RE: TRAIL MOUNTAIN MINE SEWAGE SYSTEM, PACIFICORP, COTTONWOOD MINE, ACT/015/019, EMERY COUNTY, UTAH

APPLICATION FOR PERMIT CHANGE

TRAIL MOUNTAIN MINE SEWAGE SYSTEM

ADDITION OF SEWER LINE FOR TRAIL MOUNTAIN MINE. CONNECTION TO COTTONWOOD MINE SEWAGE SYSTEM.

FIGURE 1

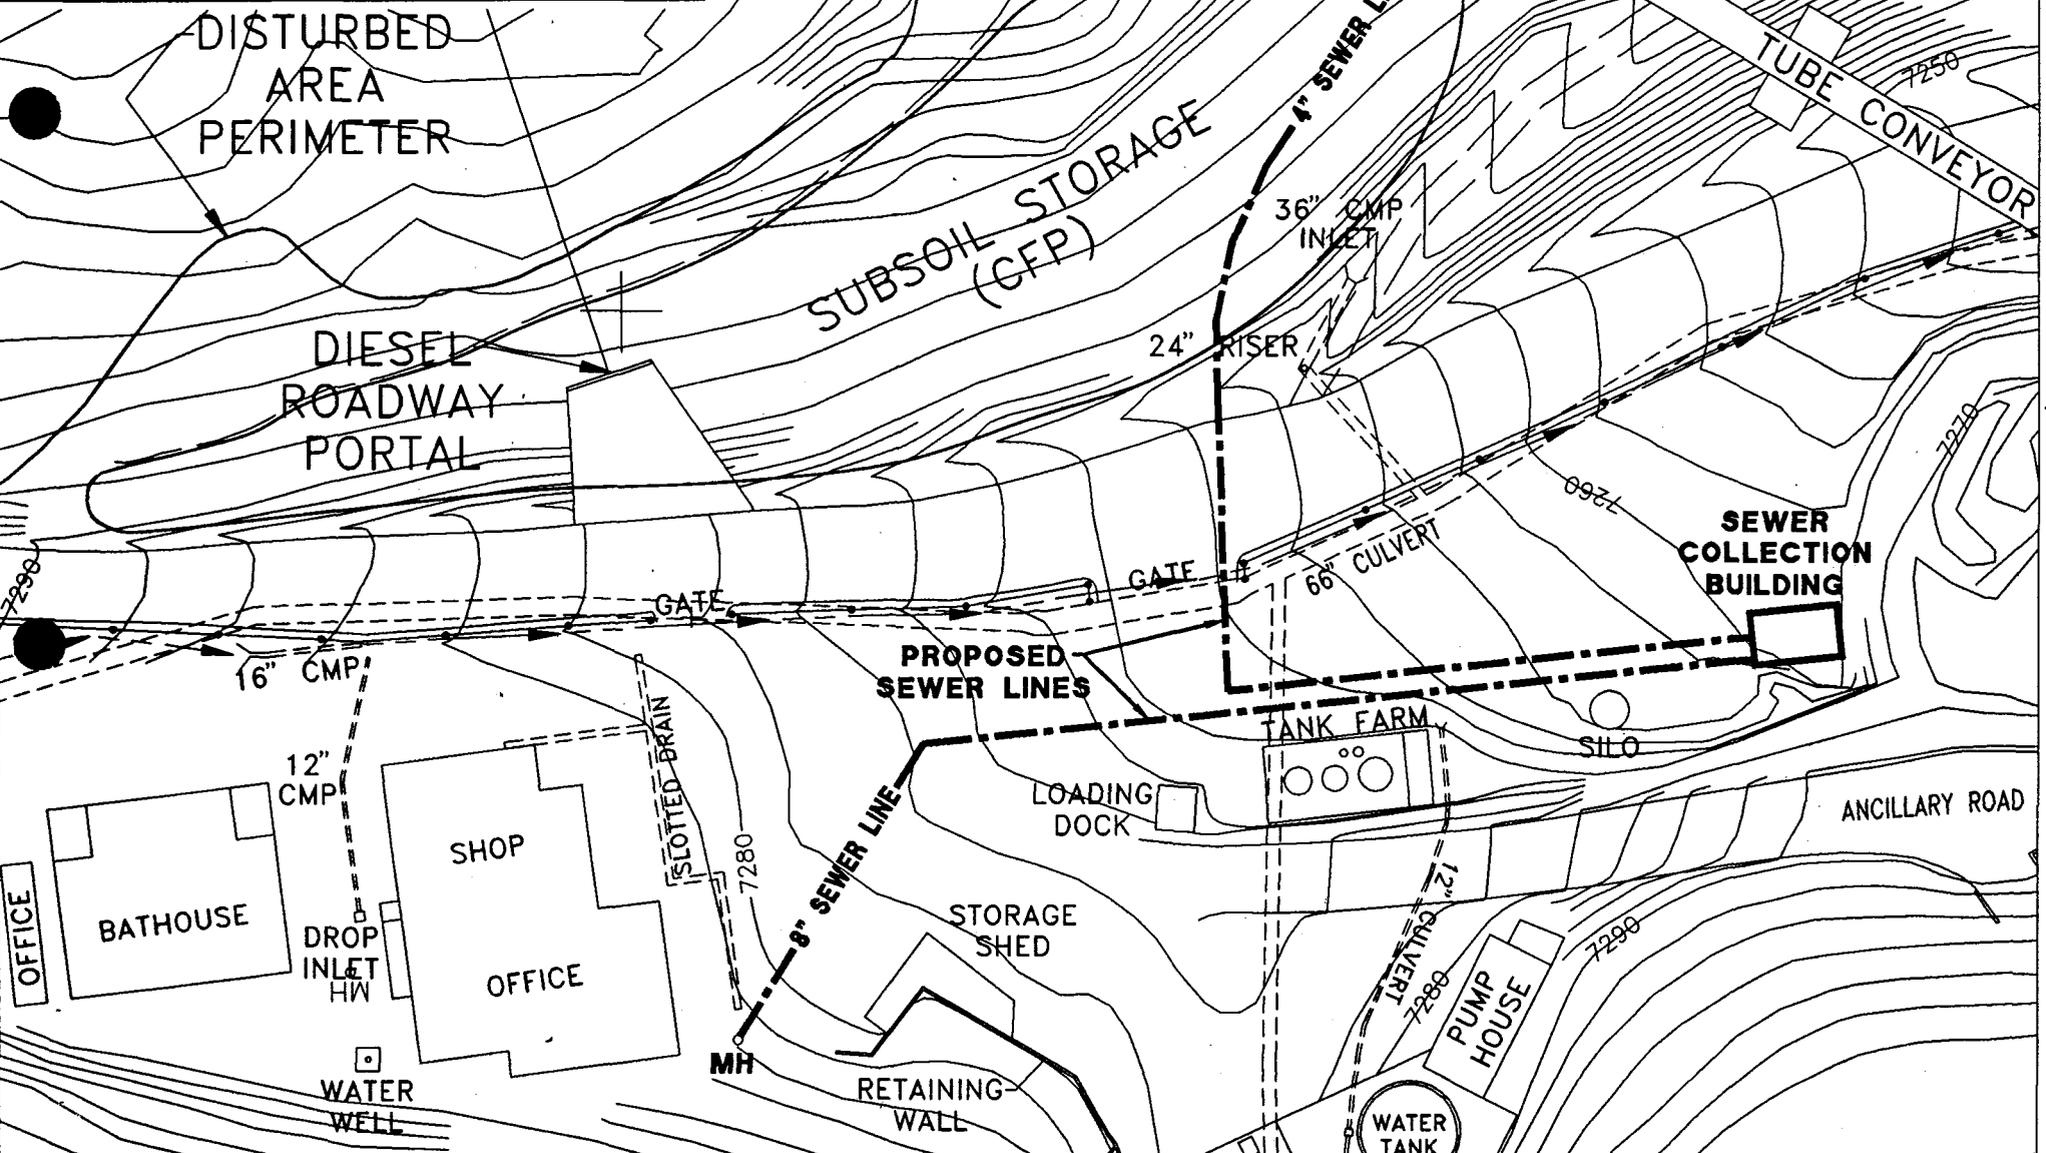
To help with the review of this amendment, Figures 1 through 3 have been included herein. Figures 1 and 3 depict the line location at the Cottonwood Canyon area and the Cottonwood Mine. Figure 2 is a typical cross-section of the buried line.
